Technical Note 1

Project: Hill Lane, Markfield

Title: Response to LCC Consultation – Planning Application 25/01157/OUT

Date: 25.03.2026

TITLE
PROPOSED ASHBY ROAD
JUNCTION IMPROVEMENT

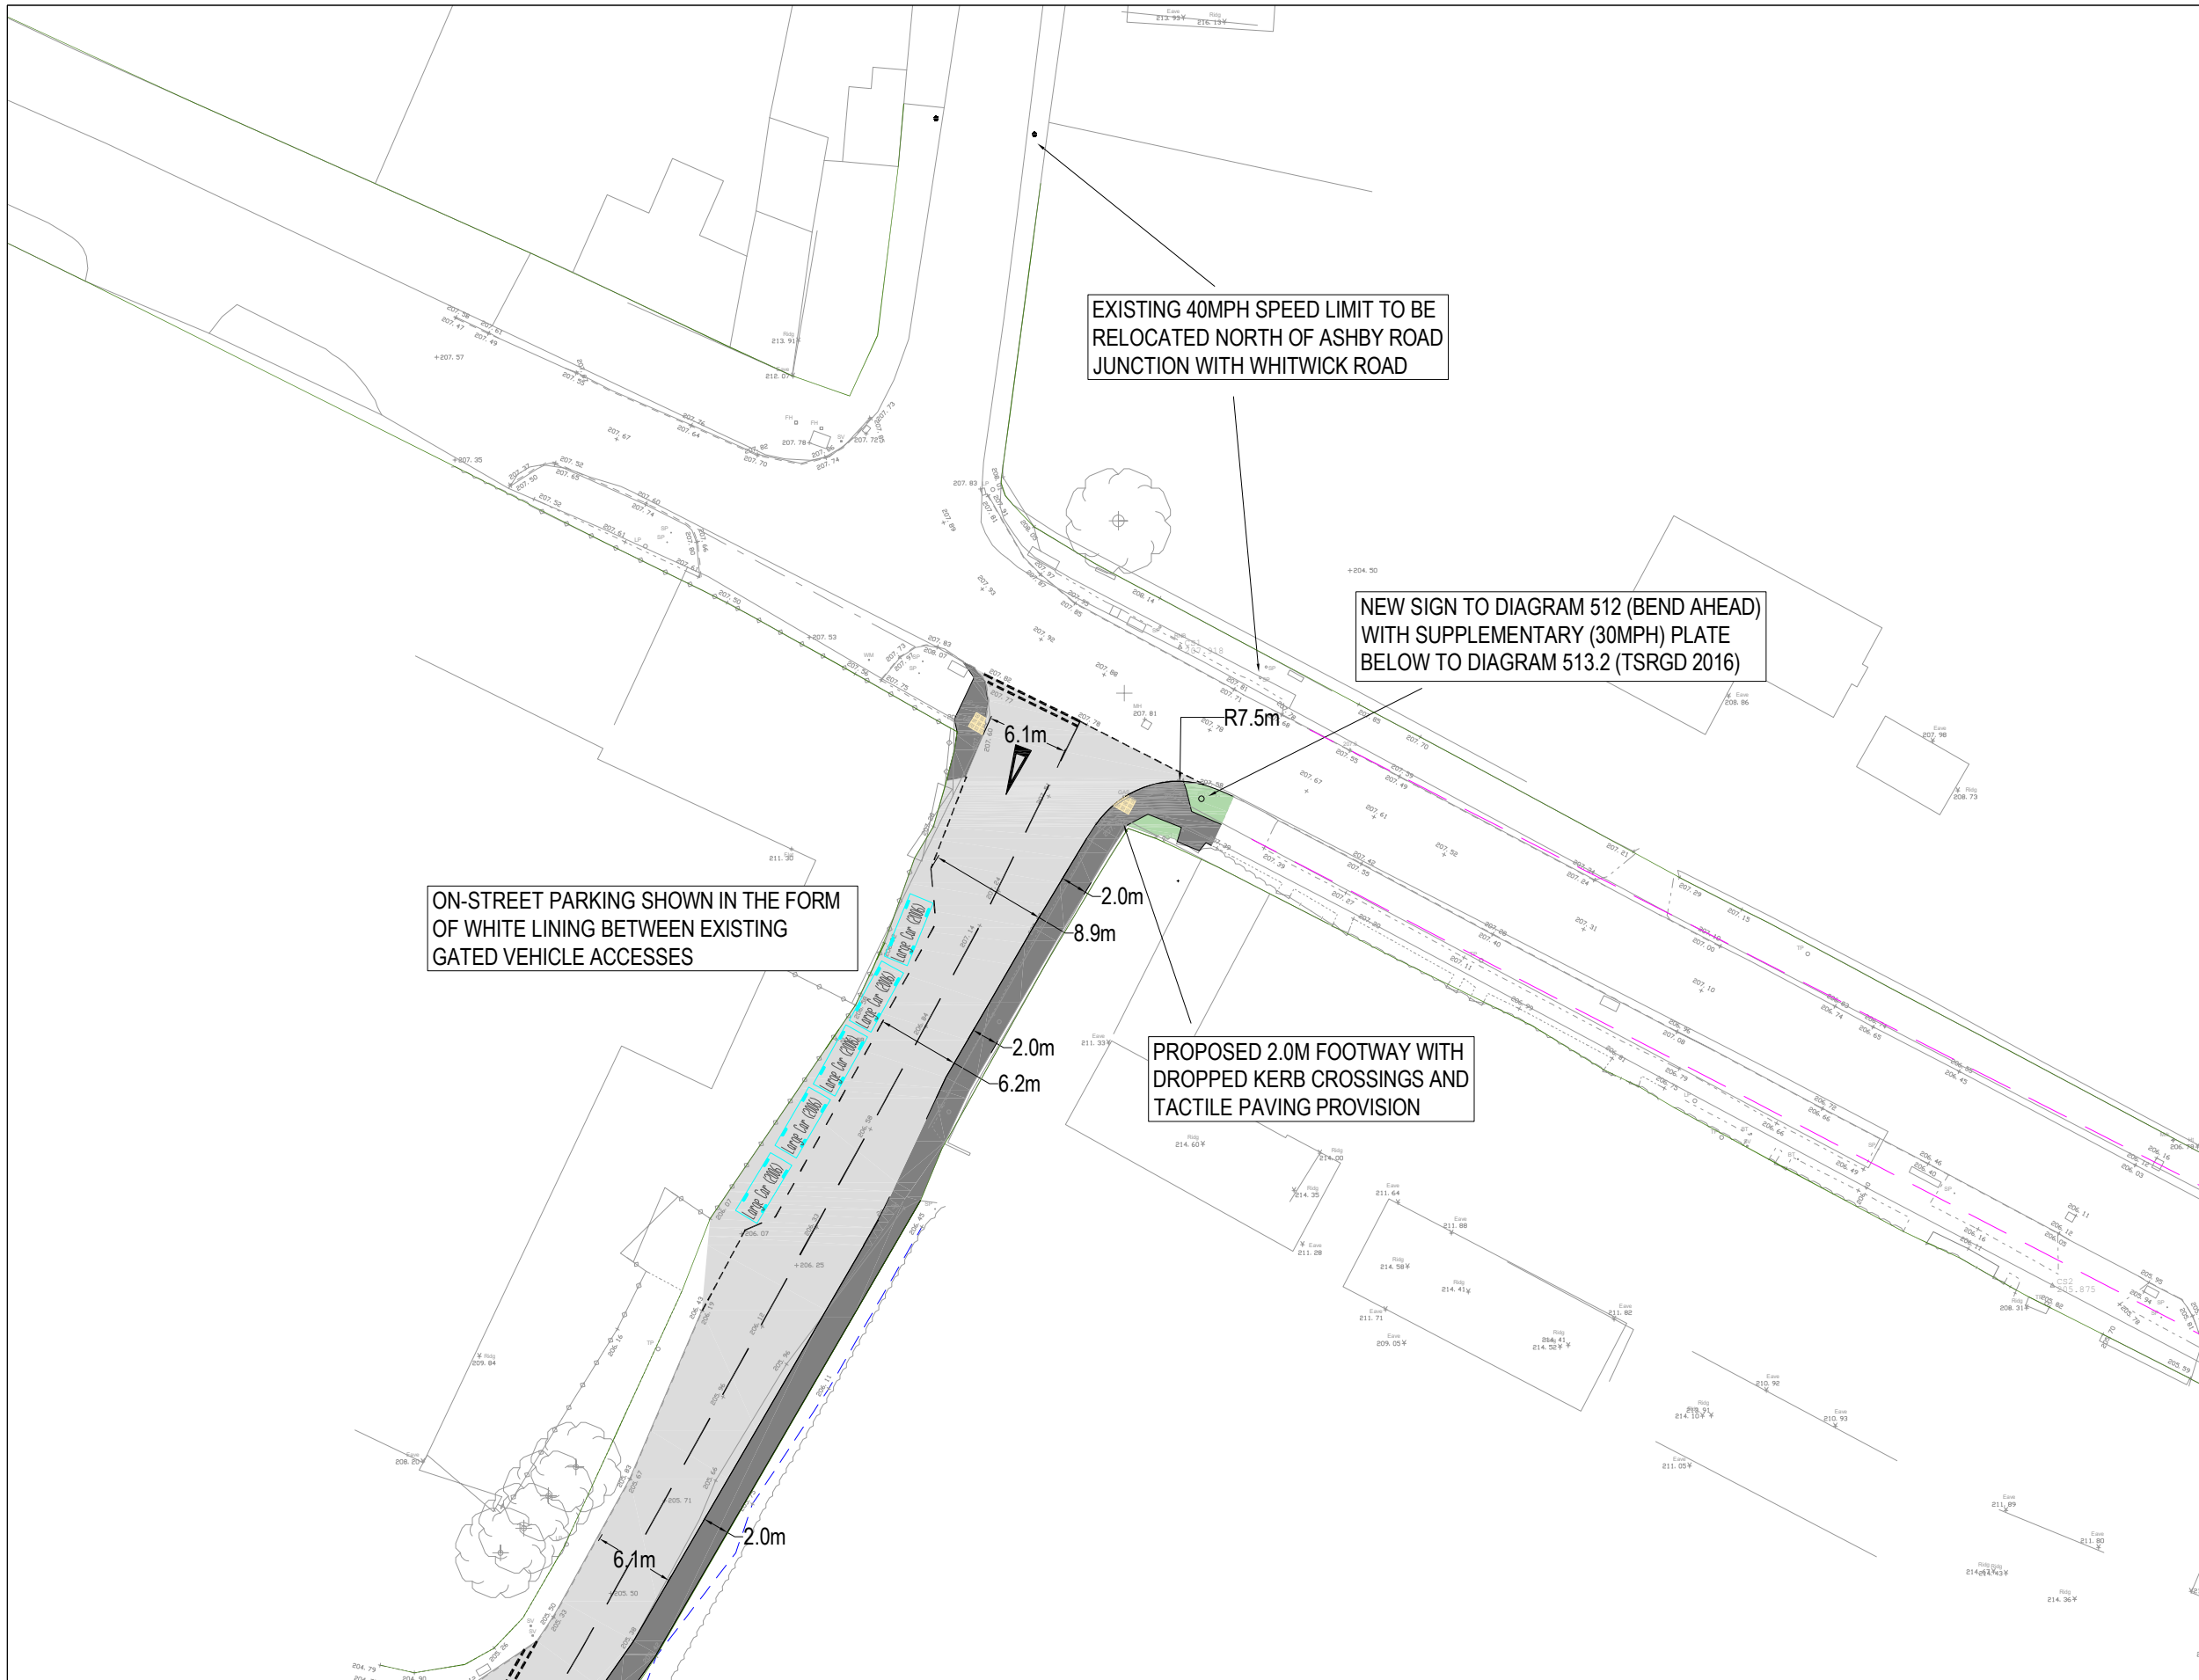
'Whilst drawing No. T25596 003 shows dimensions for the overall carriageway, lane widths should also be added. The LHA also advise that the existing on-street parking at the top of Hill Lane should be formalised through white lining. The existing centre lining should be extended to either the gateway feature or where the carriageway width is less than 5.50m. Full carriageway resurfacing and possible haunching tie in works will be required along Hill Lane adjacent to the new footway'.

- 1.23 **Drawing T25596.003 Rev A** shows additional road markings provided along Hill Lane for drivers to identify the western side of Hill Lane, south of the junction with Ashby Road, as formal on-street parking provision.

- 1.24 The drawing demonstrates that five Large Cars can be accommodated within this formal on-street parking area, whilst **Drawing T25596.004 Rev A** identifies that articulated vehicles can be accommodated along Hill Lane adjacent this proposed formal on-street parking.

TITLE
SWEEP PATH ANALYSIS 03

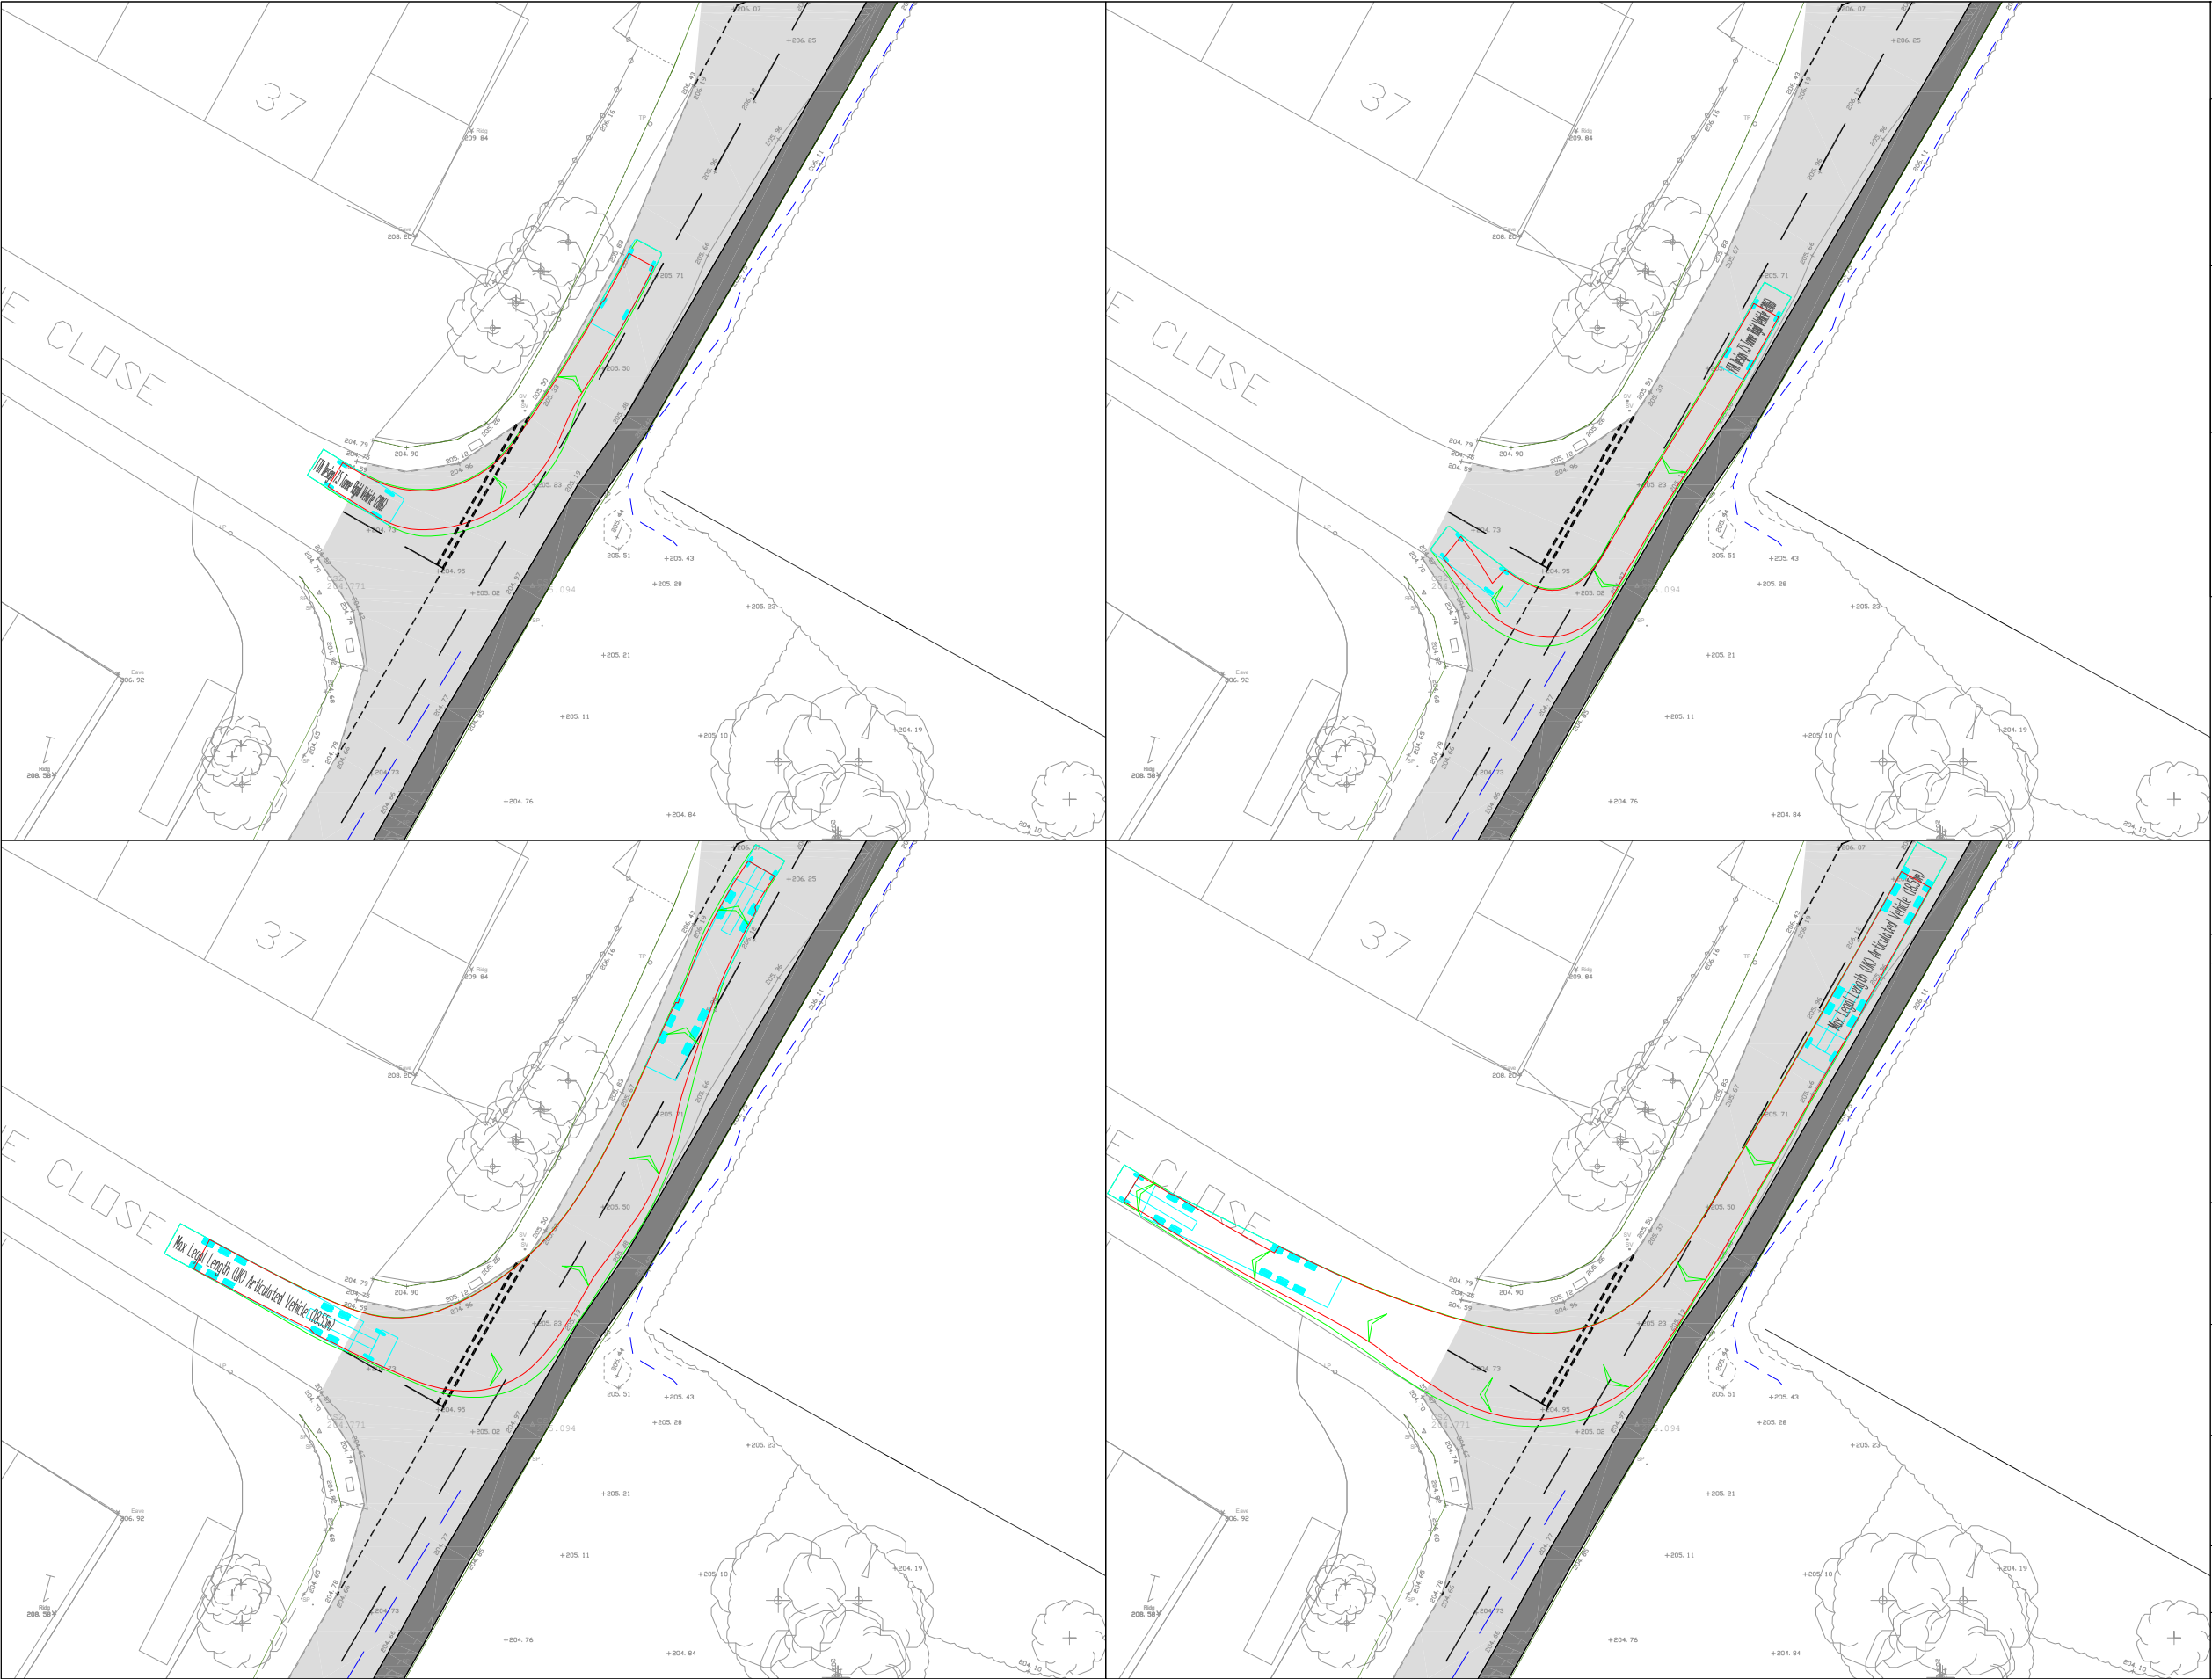
'The addition of the above footways will result in a reduction of the carriageway width of Hill Lane to 6.30m. The LHA request that drawing No. T25596 001 is amended to show existing overall carriageway widths along with lane widths. Swept path analysis drawings should be annotated to state tracking has been undertaken at a forward vehicular speed of 15kph and should be shown for an 18.55m long HGV which is the maximum length currently permitted in the UK'.

- 1.22 **Drawing T25596.005 Rev A** demonstrates that an 18.5m maximum legal articulated vehicle is able to access and egress Hill Lane Industrial Estate to/from the north without any conflicts, with the development proposals in place.

TITLE
PROPOSED HILL LANE GATEWAY
FEATURE AND SPEED LIMIT CHANGE

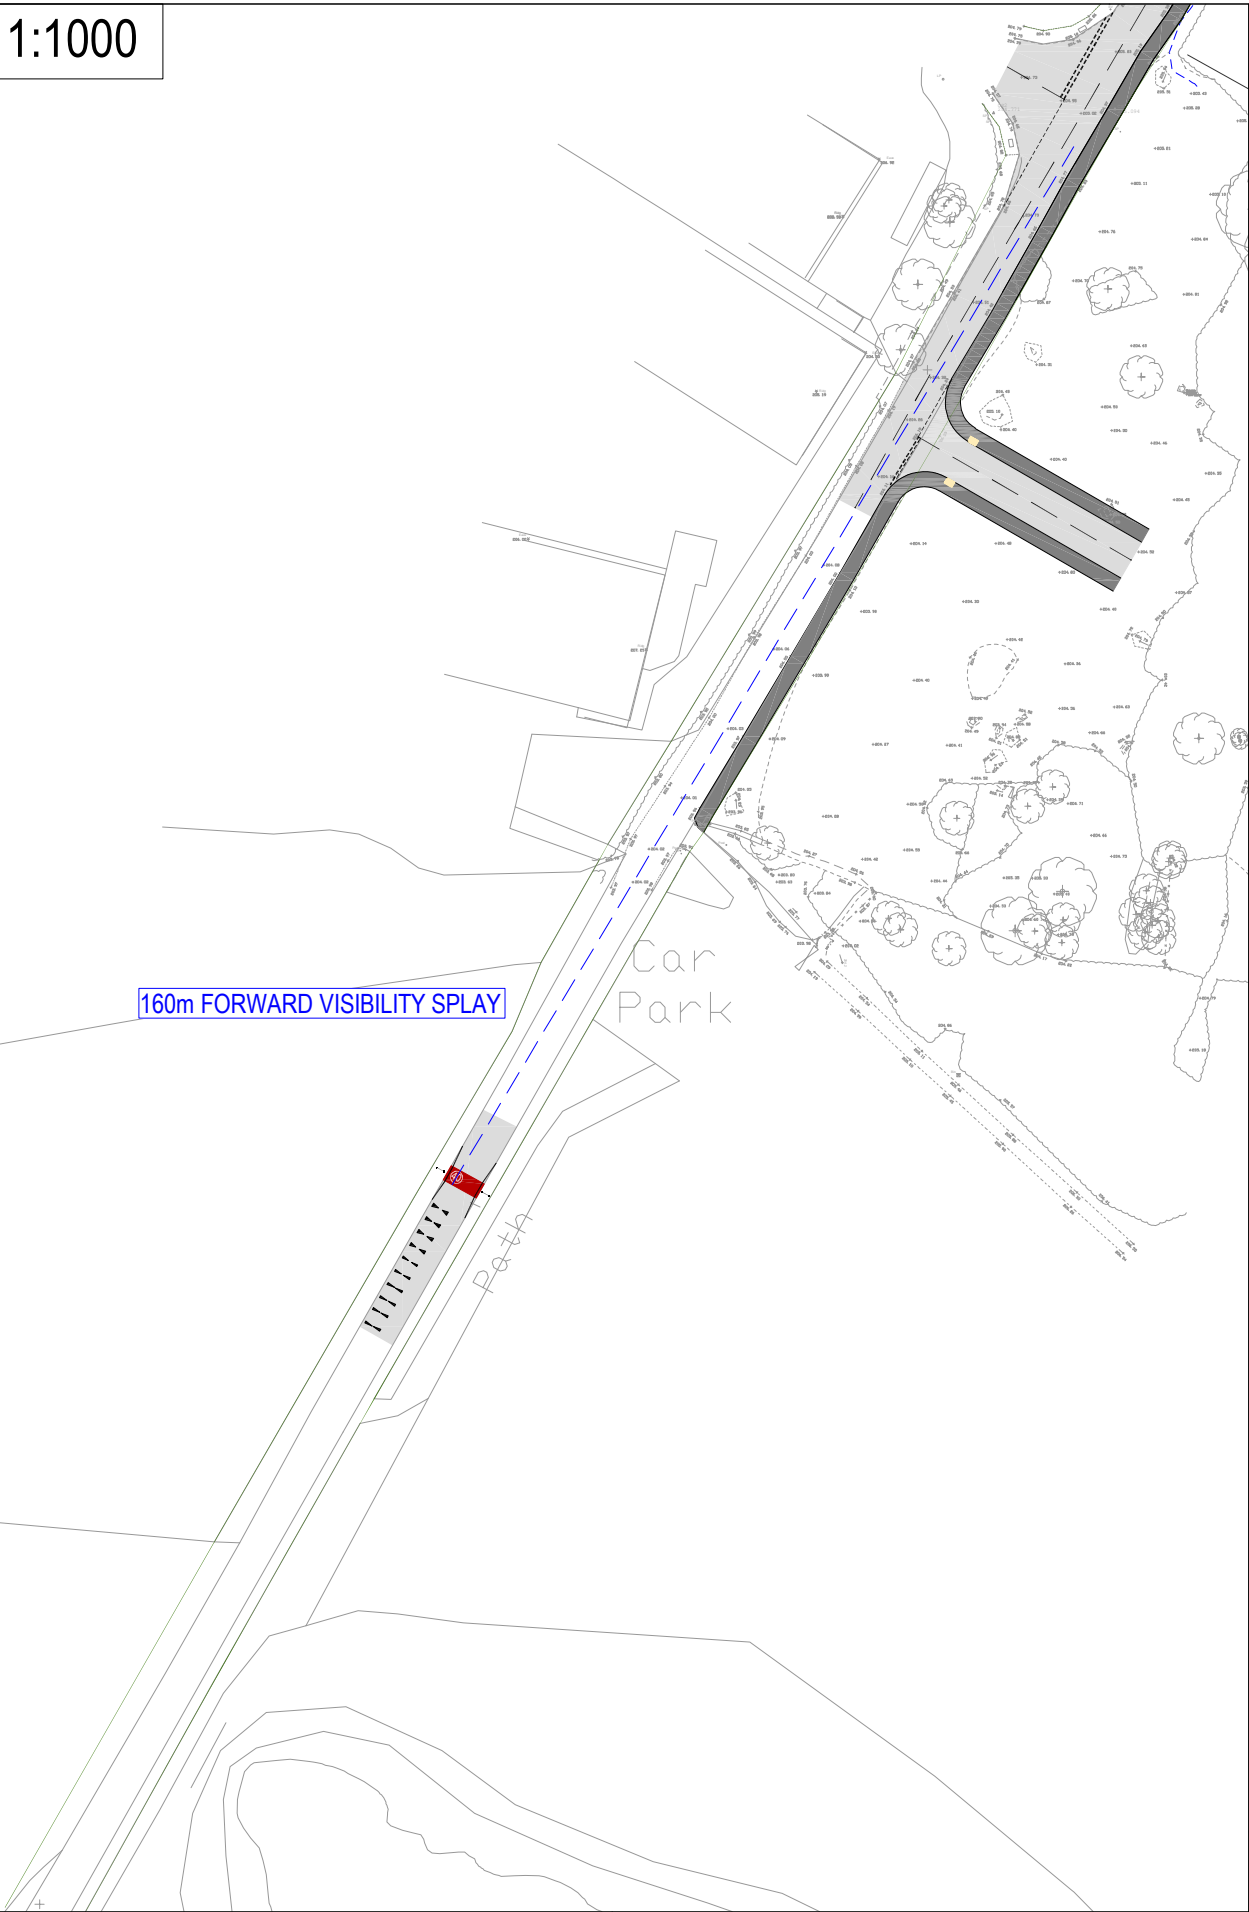
'The LHA consider that the location of the southern 40mph terminal point may not be acceptable to Leicestershire Police. Therefore, unless additional traffic calming features are proposed the LHA consider that the 40mph zone/ gateway feature should be located to the south of the car park to Hill Hole nature reserve'.

- 1.14 **Drawing T25596.006 Rev A** identifies that the proposed 40mph change in speed limit location is shifted further north of its originally proposed location along Hill Lane, immediately south of the Hill Hole Nature Reserve Car Park.

- 1.15 The drawing demonstrates that a 160m forward visibility splay can still be provided unobstructed to the proposed change in speed limit location from the north along Hill Lane.
